Regulatory Division
199404532(IP-BB)
Modification #6

Reference is made to the Department of the Army Permit, numbered 199404532, that authorized certain works for the Everglades Construction Project. The permit was issued to the South Florida Water Management District on March 13, 1997. This letter hereby modifies that permit.

Stormwater Treatment Area 3/4
including
Hydropattern Restoration
for
Water Conservation Area 3A East

Hydroperiod Restoration
for
Water Conservation Area 2A

This replaces drawing page 47 of 60 that was dated 10 MAR 97 and attached to U. S. Army Permit# 1994104532

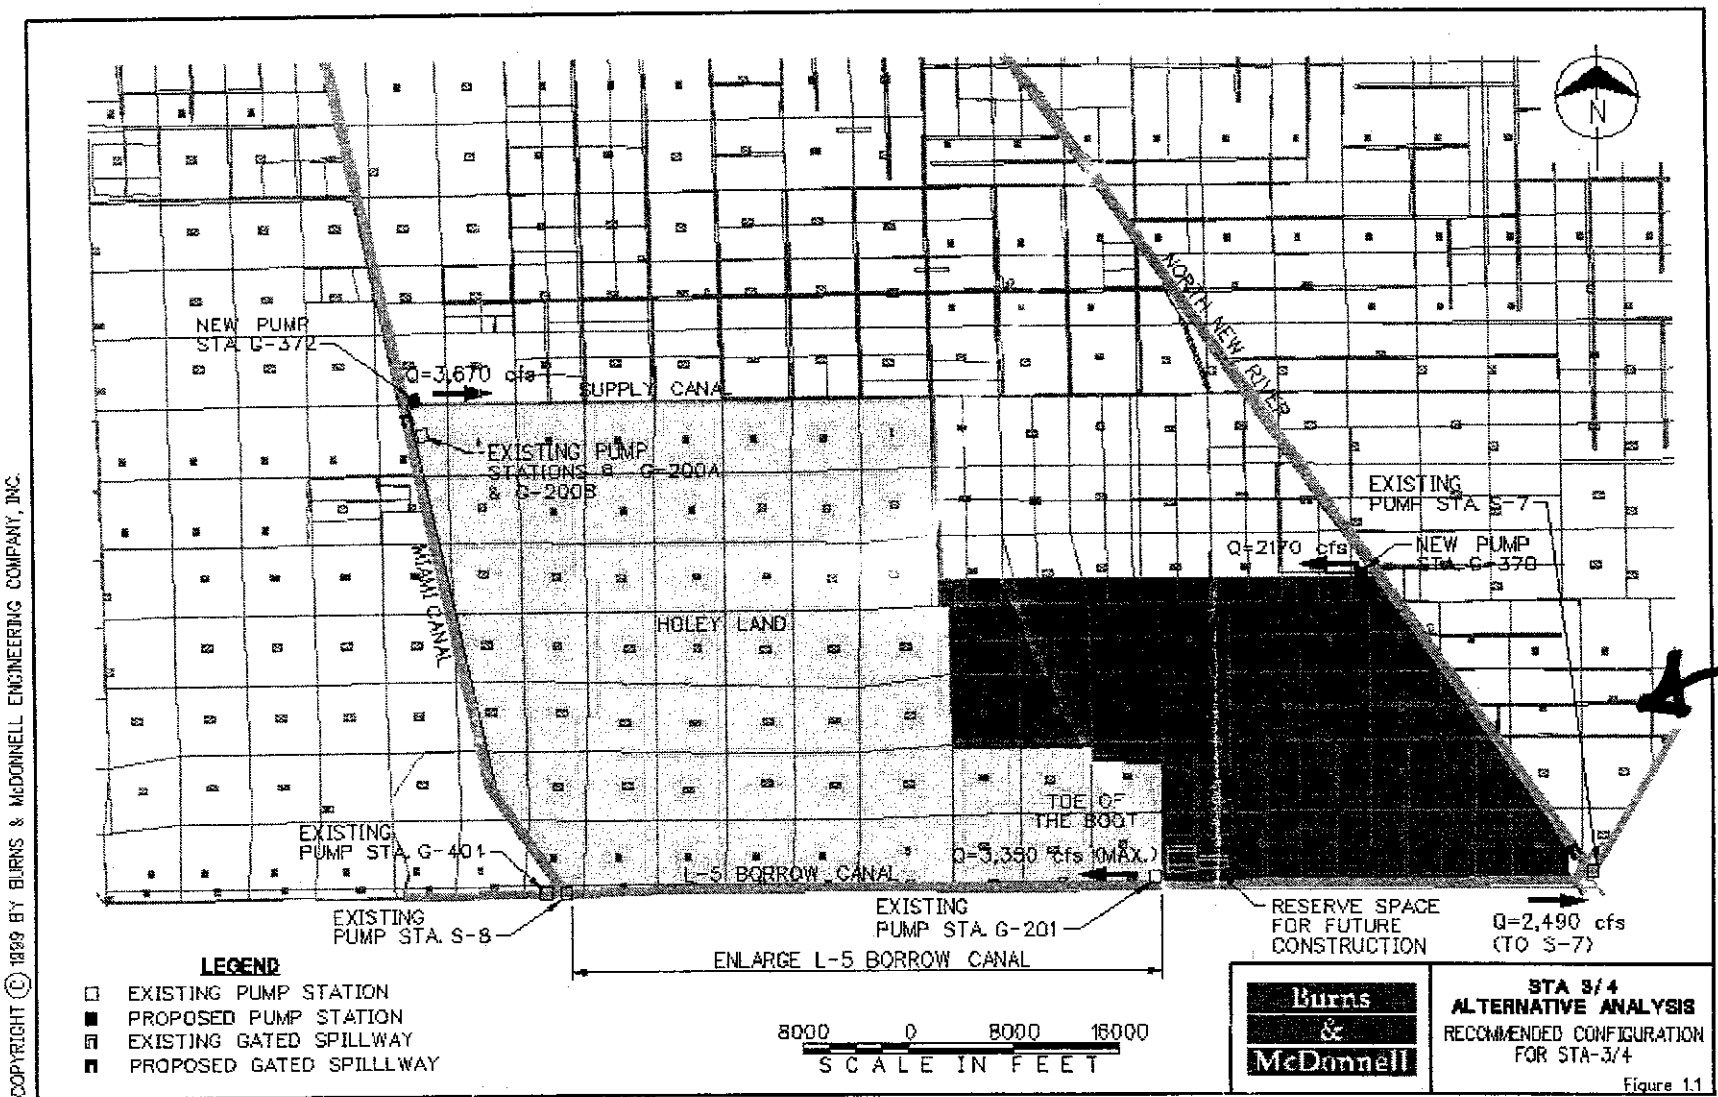
The Project Description on the first page is hereby modified by adding the following to the end of the paragraph: "<u>, and Stormwater Treatment Area 3/4 (Enclosure I)</u>" The following language is hereby inserted into the second sentence of Special Condition 4: "These works (described by Enclosure I) <u>consist of the Stormwater Treatment Area (STA) proper, the L-5 canal, and the hydropattern works. The works for the STA itself and the enlargement of the borrow canal L-5 to enable water discharging from the STA to flow to and discharge into the North New River and Miami Canals immediately upstream of Stations S-7 and S-8 respectively are authorized. The hydropattern restoration features</u> are not authorized for construction by this permit instrument." The enclosed drawings pages 47, 48, and 49 hereby replace the existing pages of the same numbers.

The works authorized at this time consist of placement of fill related to construction of: levees, seepage collection canals and return pumps to flood certain agricultural and other lands; Pump Station G-370 (on the North New River Canal), Pump Station G-372 (on the Miami Canal) and inflow distribution canals and control structures along the northern perimeter of the treatment area; certain interior levees, a collection canal and structures along the southern perimeter of the treatment area to discharge flows into existing Canal L-5; widening of Canal L-5 along the southern perimeter of the Holey Land. The project will provide an effective treatment area of approximately 16,660 acres. The works are described by the drawings on pages 48 to 51.

This replaces drawing page 18 of 60 that was dated 24 FEB 00 and attached to U. S. Army Permit# 1994-015-32

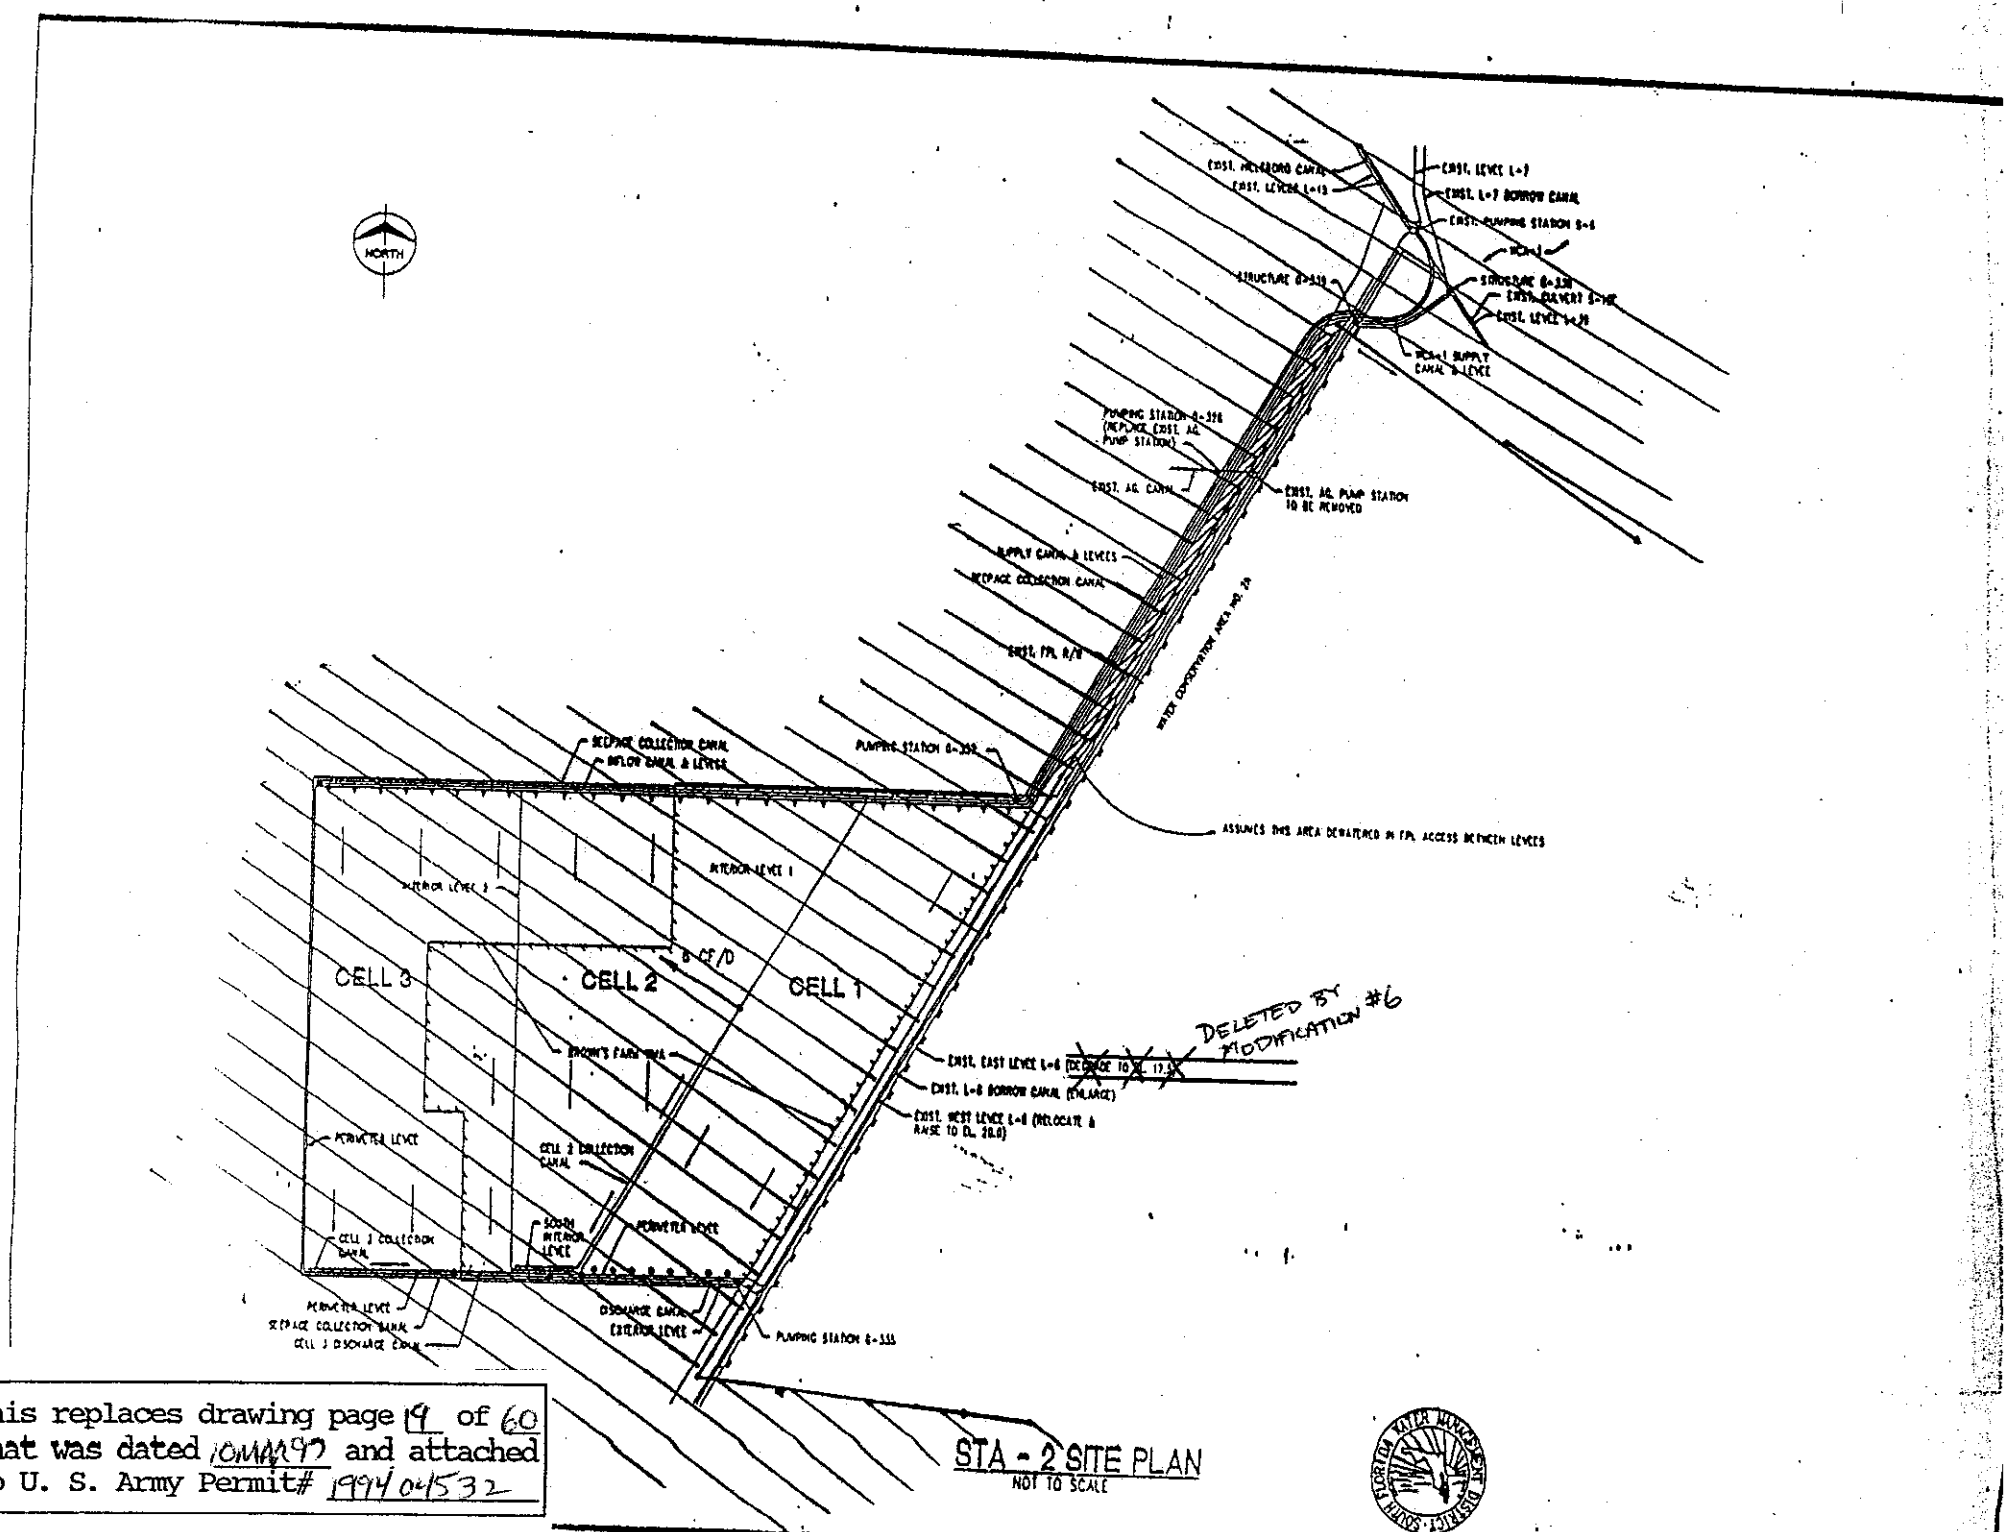
The enclosed drawing page 18 hereby replaces the existing page 18 added by Modification #5, drawing page 19 and 20 replaces the existing pages, and drawings page 20B, 20C and 20D are hereby added to the permit instrument to add work related plugging the L-6 borrow canal near S-7, placing a control structure, raising West Levee L-6, and degrading East L-6 Levee near S-7. The changes in the drawings also eliminate the originally planned extent of degradation of East Levee L-6. The locations for water to flow from STA-2 into WCA-2A are now, at the north end of Borrow Canal L-6, the 6 culverts described by the previous Modification #5 and, at the south end, across the approximately 15,000 feet of degraded East Levee L-6.

This replaces drawing page 19 of 60 that was dated 10MAY97 and attached to U. S. Army Permit# 1994/04532

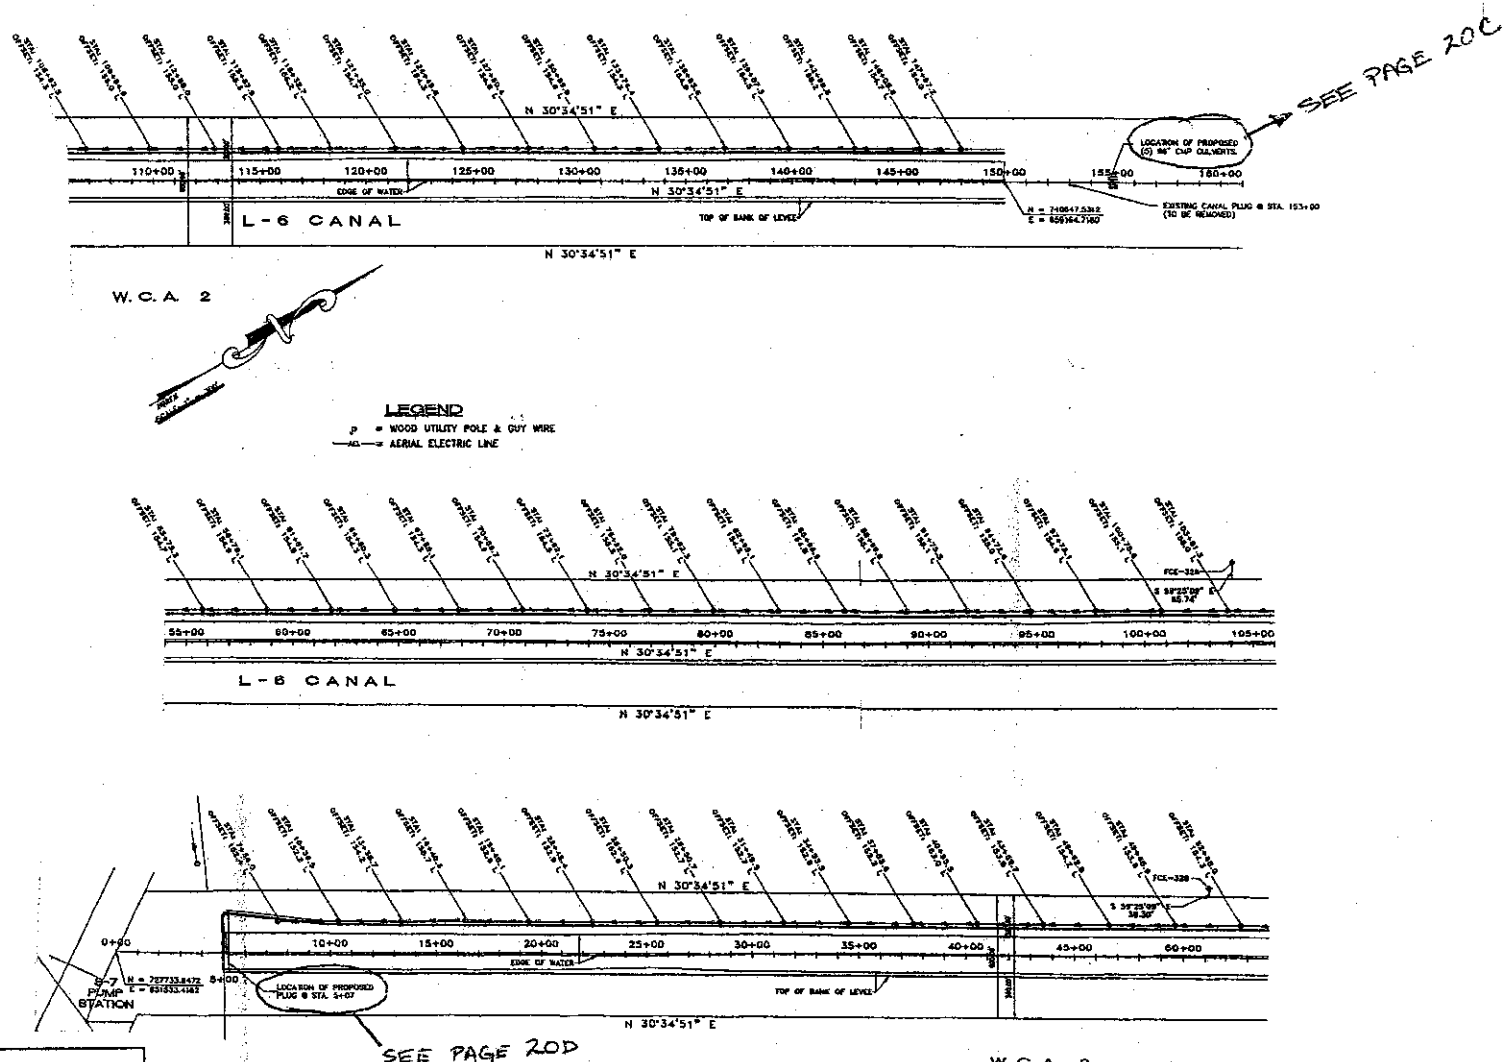
(Added by Modification) #6
The degradation of East Levee L-6 is now limited to its south end from Station 5+14 to 150+00. Fill is placed in Borrow Canal L-6 from for a plug from Station 5+00 to 5+14 and is placed at approximately 150+00 for a water control structure. Fill is placed along West Levee L-6 from Station 5+00 to 151+40.
